Regarding Lahontan Water Board's Consideration of Amendment of Order No. R6V-2011-0005A1 (Order) Issued to Pacific Gas and Electric Company (PG&E), as Described in Your "Comments Requested by April 23, 2012" Letter of March 22, 2012.

Comments submitted by the Community Advisory Committee (CAC.)

Figure 1: Lahontan RWQCB Order No. R6V-2011-0005A1 Issued to PG&E. Harold J. Singer's March 22, 2012 Solicitation of Comments Regarding the Order's Section 3.a.

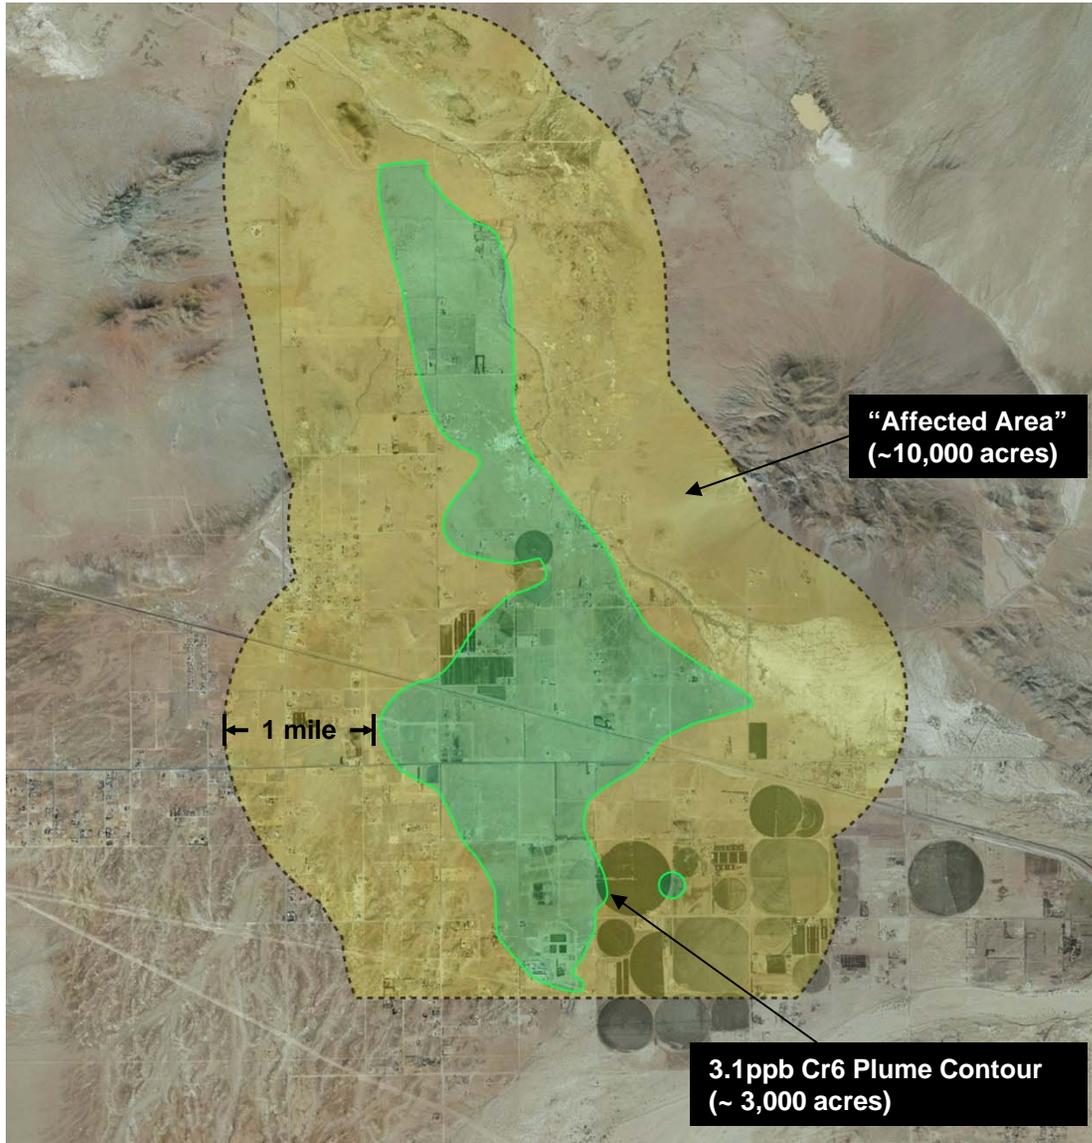
The geographic locations of interest are depicted in **Figure 1**. From a lateral extent of impacts perspective, it is worthwhile to note that the acreage internal to 3.1µg/l Cr6 plume is approximately 3,000 acres, while the "1 mile outer annulus," area where the Order's Paragraph 3.a. is focused, is approximately 10,000 acres. In a broad sense then, as Cr6 issues affect the Hinkley Community, PG&E's obligations to devise plume assessment and interpretation methodologies, and source of Cr6 differentiation methodologies, which address the impacts of their Cr6 releases external to the somewhat arbitrarily defined 3.1µg/l contoured plume³, are equally important to the Hinkley Community as efforts focused internal to the 3.1µg/l plume contour.

- "Impacted Wells" are those containing Cr6 greater than 3.1ppb in the "Affected Area," or, wells within the "Affected Area" with Cr6 greater than 0.02ppb, where the Cr6 is proven to have been discharged by PG&E.

- "Affected Area" is defined as all domestic wells located laterally within 1 mile, down gradient or cross gradient of the 3.1ppb Cr6 plume.
- The Order's Section 3.a. requires PG&E to submit a methodology to determine if Cr6 in domestic wells in the "Affected Area" were caused, in whole or in part, by PG&E's discharge.
